City of Fresno
Design Guidelines
California High-Speed Train Project
June 15, 2012

The Design-Build proposal and bidding process is now underway and the City of Fresno is concerned about the look and feel of HSR infrastructure in Fresno. To that end, the City desired an independent review of the current 15% design documents that are the basis of design for the five Design-Build Teams. This abbreviated report is a summary of that independent review and recommendations for additional design requirements to be considered by CHSRA as addenda in the design documents being used by the Design-Build teams currently.

Figure 2-8
Elevated Structure Typical Cross Sections

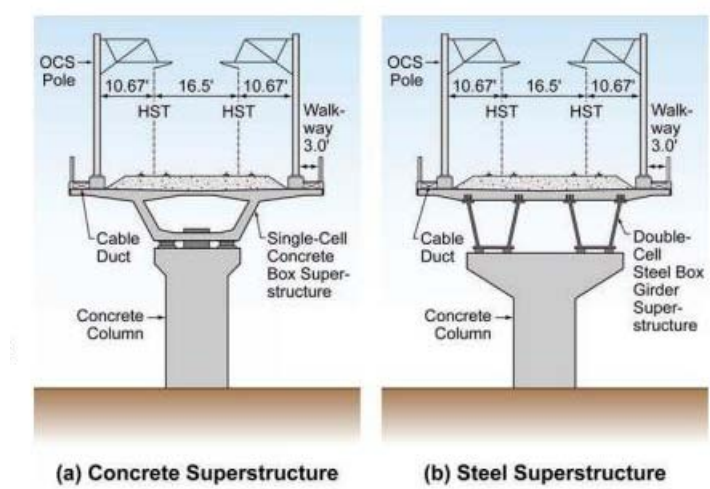
The typical elevated portion of the alignment throughout much of the state-wide alignment and portions of Fresno is a single or twin box girder structure on single, flared piers. As indicated in the Concept Approach to HSR Design above and building on the CHSRA Architectural Guidelines, the recommended aesthetic design is aerodynamic, monolithic and curved/softened edges. The primary components are piers, a flared box section, deck overhangs with parapet type edge barriers and twin OCS poles. Steel superstructure box girder options may require additional work with deck and pier top to create a smooth relationship between pier and flared girders.

Recommendations: aerodynamic forms; curved edges; monolithic surfaces.

15% Engineering Drawings: Typical straddle bent design concept

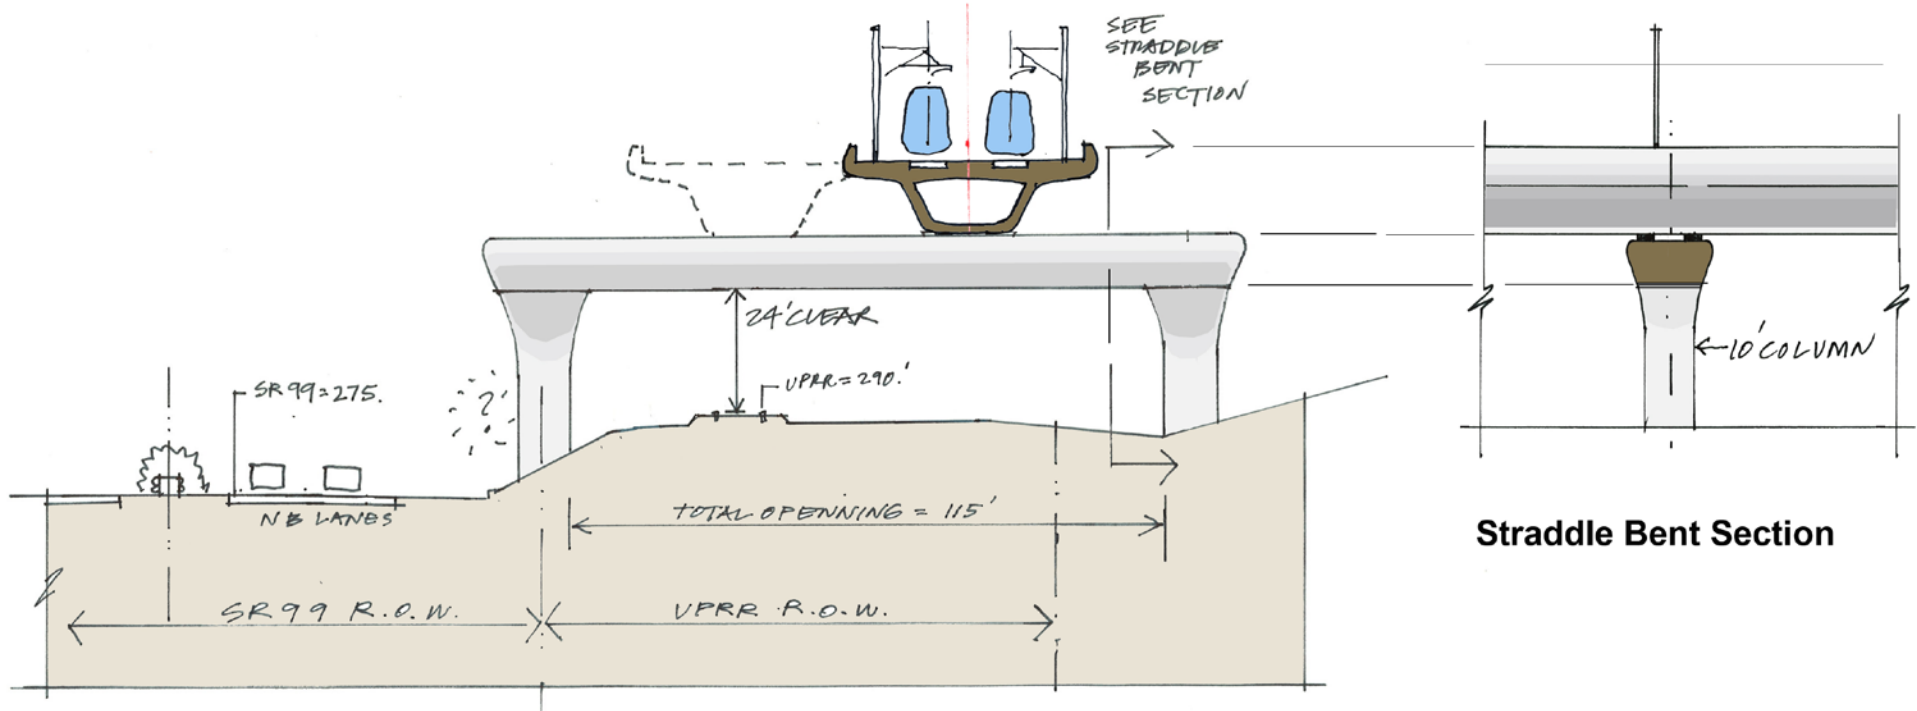
Our recommendation is that straddle bents follow the same aesthetic guidelines applied to the general guideway: twin piers of the same flared form as the single, center pier, joined by a robust beam with curved edges and ends and cross section that approximate the flare of the piers. In order to convey the uniform and smooth appearance, integrated bents are preferred over composite bents. This will give a continuous line to both structures and keep straddle bents in the unified family of forms.

Recommendation: Curved, smooth saddle bents to match the speed and design of HSR vehicles.

Proposed: typical conceptual engineering design for most overcrossings in the northern neighborhoods

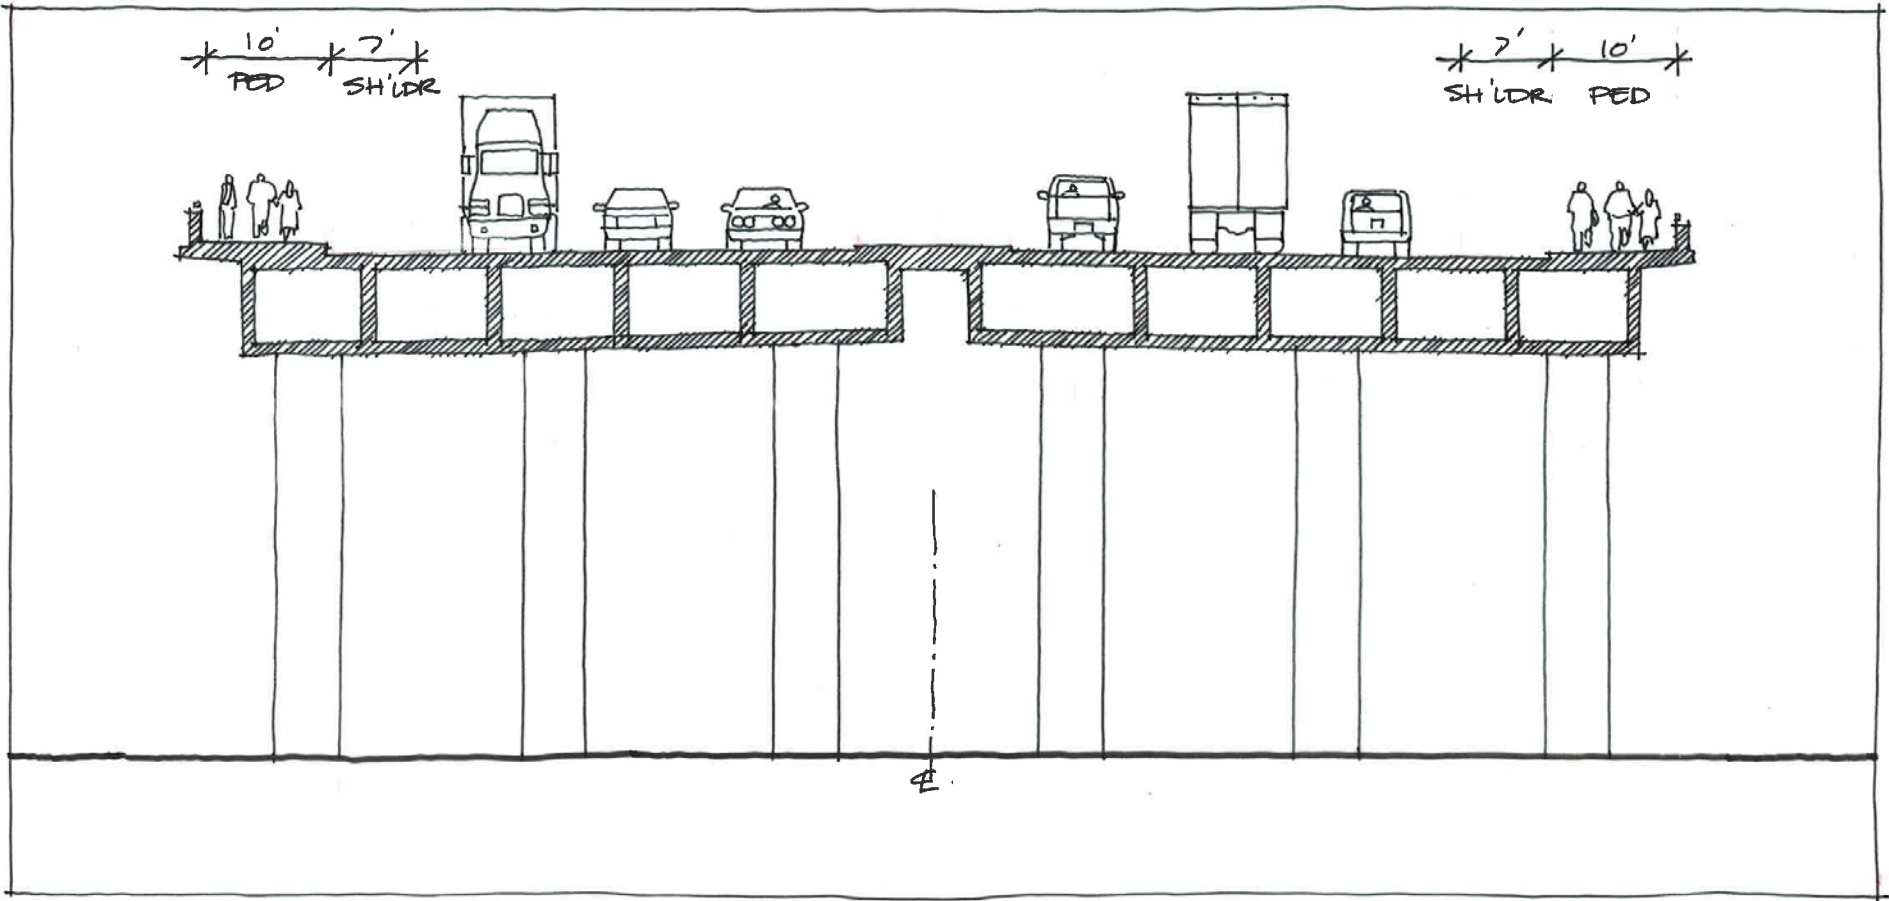
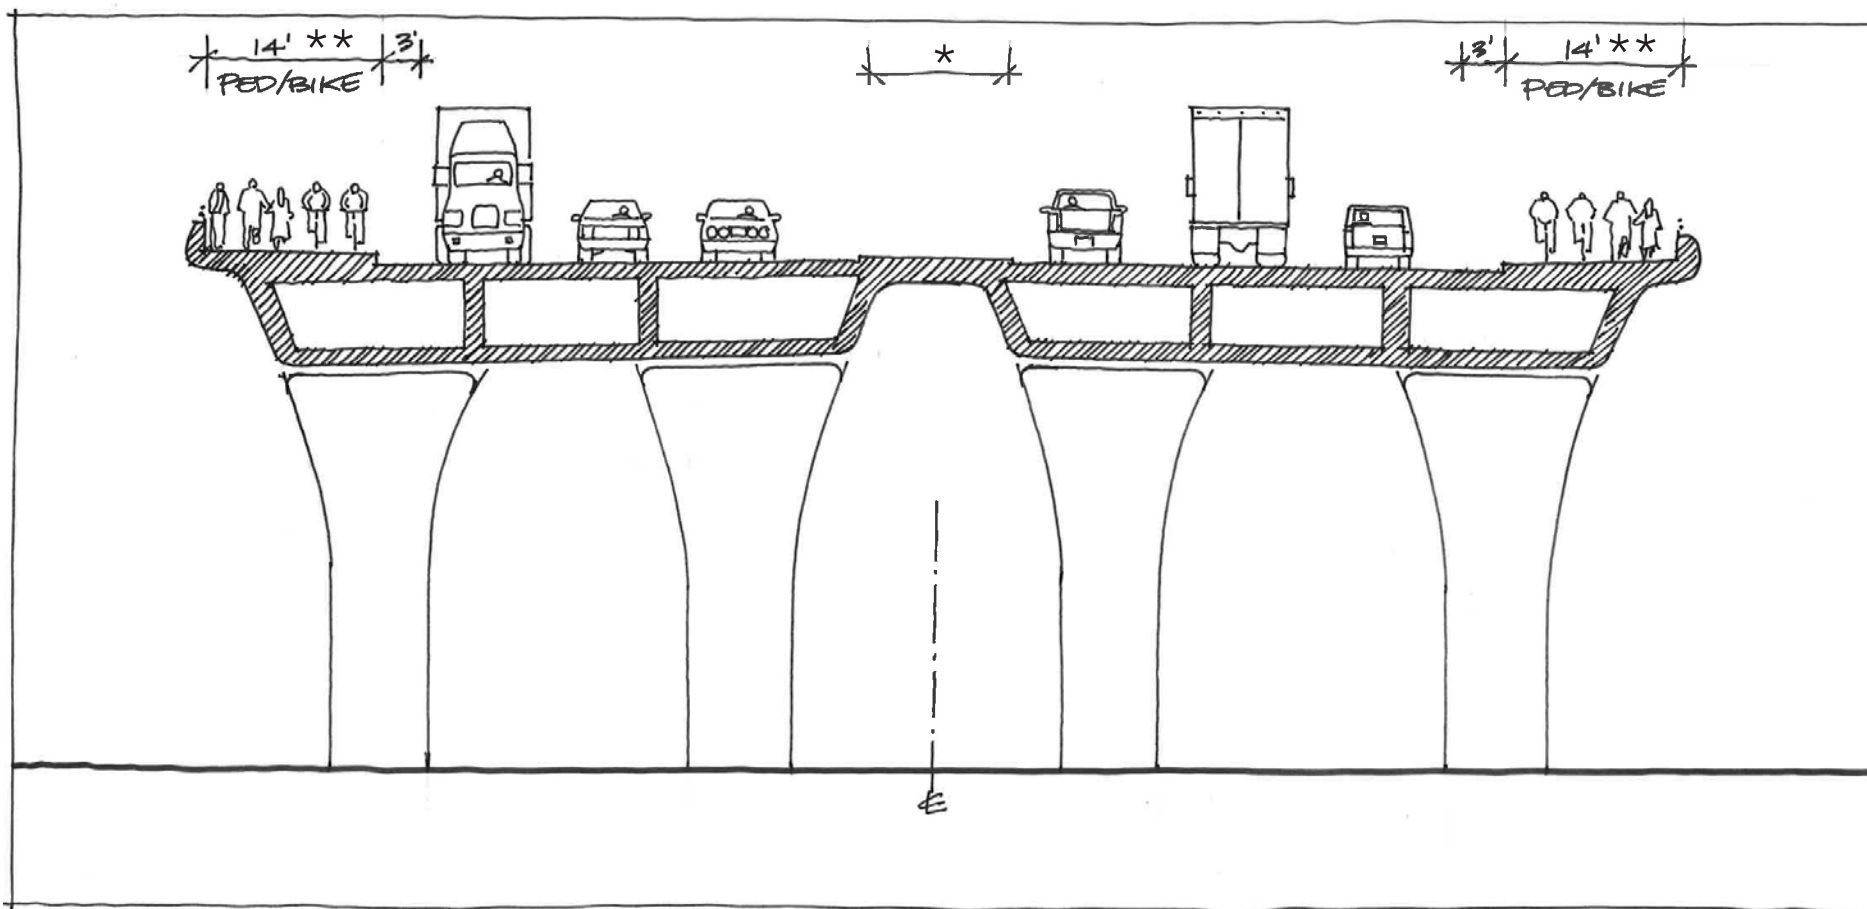
Current HSR design documents, represented by the illustration at right, indicate new overcrossings with standard composite box girders and round, straight piers at close spacing. This is a departure from the form and look of the HSR guideway itself.

Additionally, varying levels of pedestrian and bicycle accommodation are planned for streets crossing over the HSR alignment. At right, the 15% preliminary engineering concept for Shaw Avenue is illustrated with a 10' sidewalk and a 7' shoulder on each side, but some crossings include only one sidewalk.

The drawing on page 31 portrays a recommended set of elements for these crossings, with combined 14' pedestrian and bicycle facilities, separated from auto lanes on both sides of each overpass

Recommended Design: incorporate HSR design themes and provide usable pedestrian and bicycle facilities

Proposed conceptual engineering design*

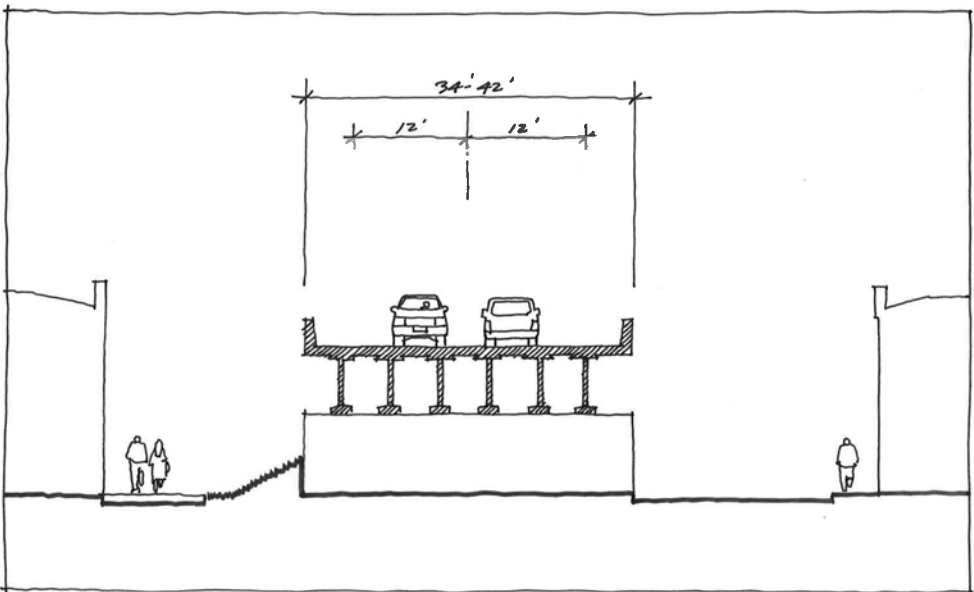
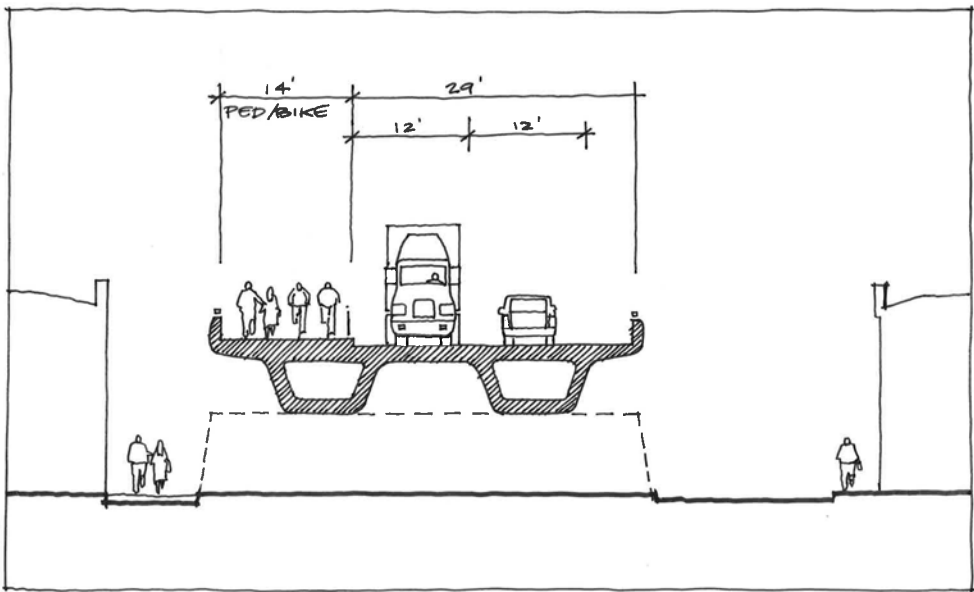
Stanislaus is currently a C3-designated (high-volume, one-way) street. Together with Tuolumne, it forms a one way couplet. As part of the CHSR project, the Stanislaus Street Bridge will be rebuilt as a two-way, four lane facility to replace the function and capacity of the couplet. The Design-Build teams need to confirm if the full-width pedestrian- bicycles facility can be added to the travel lanes and still fit within the 100' right-of-way.

Recommended design*
